PREVOST

**WARRANTY
BULLETIN**

WB19-02A

DATE :	April 2019	SECTION :	01 ENGINE
EXPIRATION:	April 2021		
SUBJECT :	ALTERNATOR IDLER SUPPORT REPLACEMENT

FIGURE 2

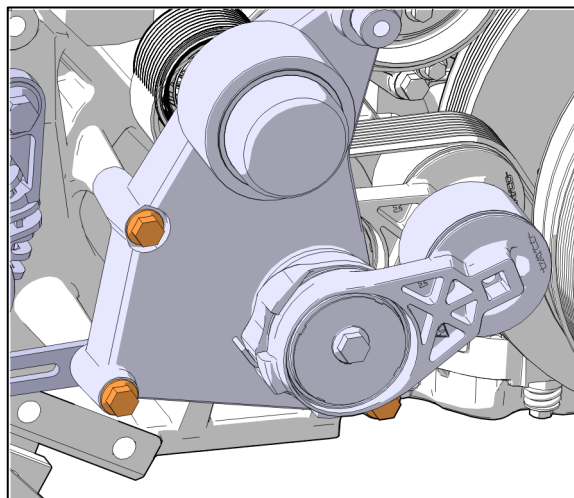
4. Remove the idler support by unscrewing the three screws. Keep hardware for reuse.

Support must be scrapped. It must not be reused on vehicles.

FIGURE 3

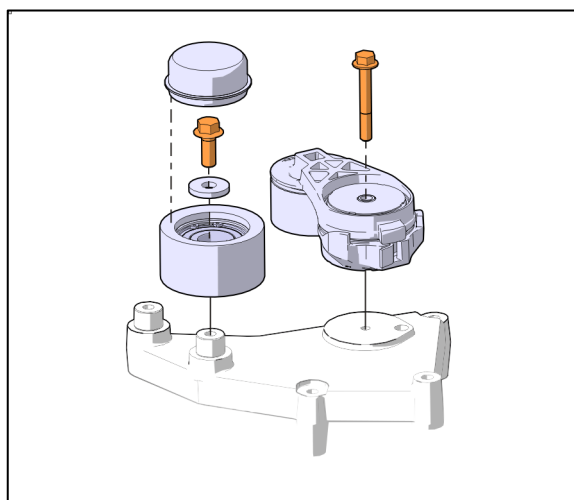
5. Remove idler and belt tensioner.
6. Take note of the idler position as it may be installed higher or lower on the support.
7. Discard support. Keep idler and tensioner. Keep hardware for reuse.

FIGURE 4

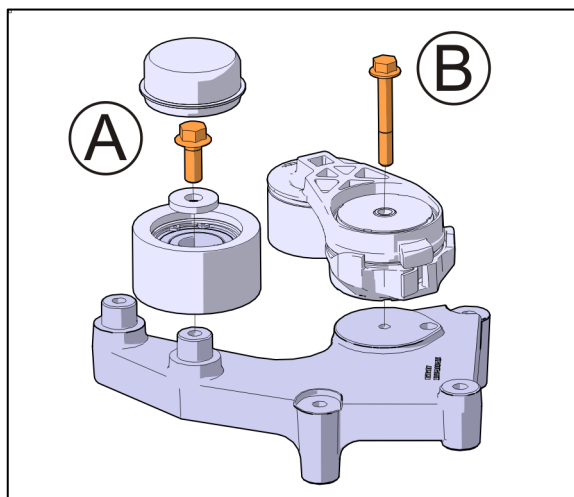
8. Clean mounting surfaces, screws and threaded holes with brake cleaner.
9. Transfer idler **A** to new support.
Assemble with Loctite 243
Tighten screw 5001786 to **59 lb-ft.**
Apply torque seal marks.
10. Transfer belt tensioner **B** to new support.
Assemble with Loctite 243
Tighten screw 5001799 to **48 lb-ft.**
Apply torque seal marks.

FIGURE 5

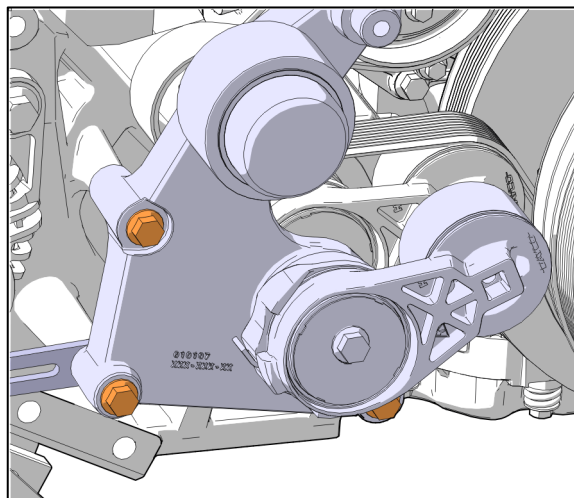
11. Clean mounting holes.
12. Install new idler support.
13. Assemble screws with Loctite 243.
Tighten screw 5001799 to **48 lb-ft**.
Apply torque seal mark.
